Access Compliance Report

Public Rights-of-Way

(Curb Ramps)

Intersection ID: 29777	Main Street: REA_RD	Cross Street: WILLIAMS_POND_LN	Location: S
ADA ID: D432EC018922	Ramp Type: Perp	Initial Pass/Fail: Fail	Overall Compliance: No
Severity Score: 12.5			
Codes/Mitigation Info/Possible Solution		Field Measurements/Component Compliance

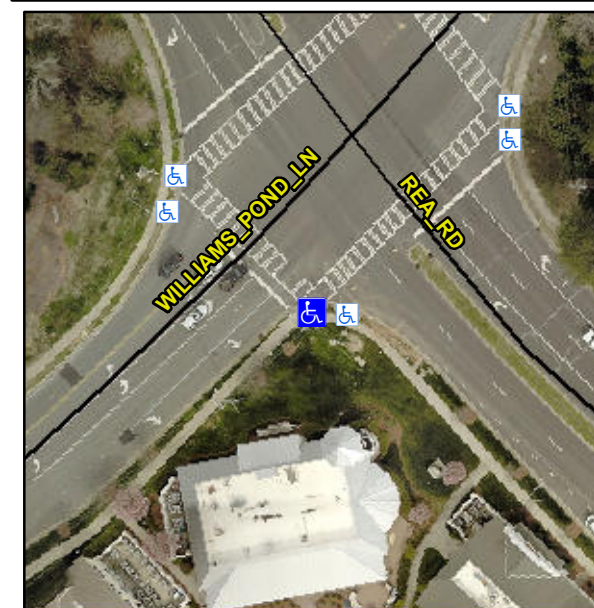
Not Found, R304.5.3

Compliance	Description	Data	Compliance	Description	Data
N/A	Ramp Length (in)	101.0	Yes	Ramp Slope (%)	6.7
Yes	Ramp Width (in)	48.0	No	Ramp XSlope (%)	5.2
N/A	Flare Type LT	N/A	N/A	Flare Type RT	N/A
N/A	Flare Slope LT (%)	N/A	N/A	Flare Slope RT (%)	N/A
N/A	Flare Traversable LT?	N/A	N/A	Flare Traversable RT?	N/A
N/A	Landing Length (in)	N/A	N/A	DWS Provided?	N/A
N/A	Landing Width (in)	N/A	N/A	DWS Contrast?	N/A
N/A	Landing Slope (%)	N/A	N/A	DWS Length (in)	N/A
N/A	Landing X Slope (%)	N/A	N/A	DWS Full Width?	N/A
N/A	Landing Curb? (Y/N)	N/A	N/A	DWS Offset (in)	N/A
N/A	Shared Landing?	N/A			
N/A	Gutter Ponding?	N/A	N/A	Gutter Slope (%)	N/A
N/A	Gutter Lip Ht (in)	N/A	N/A	Gutter X Slope (%)	N/A
N/A	Painted X Walk1?	Yes	N/A	Painted X Walk2?	N/A
	X Walk 1 Direction	To NW		X Walk 2 Direction	N/A
N/A	X Walk 1 Width (in)	112.0	N/A	X Walk 2 Width (in)	N/A
	X Walk 1 Slope (%)	2.1		X Walk 2 Slope (%)	N/A
	X Walk 1 X Slope (%)	2.6		X Walk 2 X Slope (%)	N/A

Remove & Replace Entire Ramp.
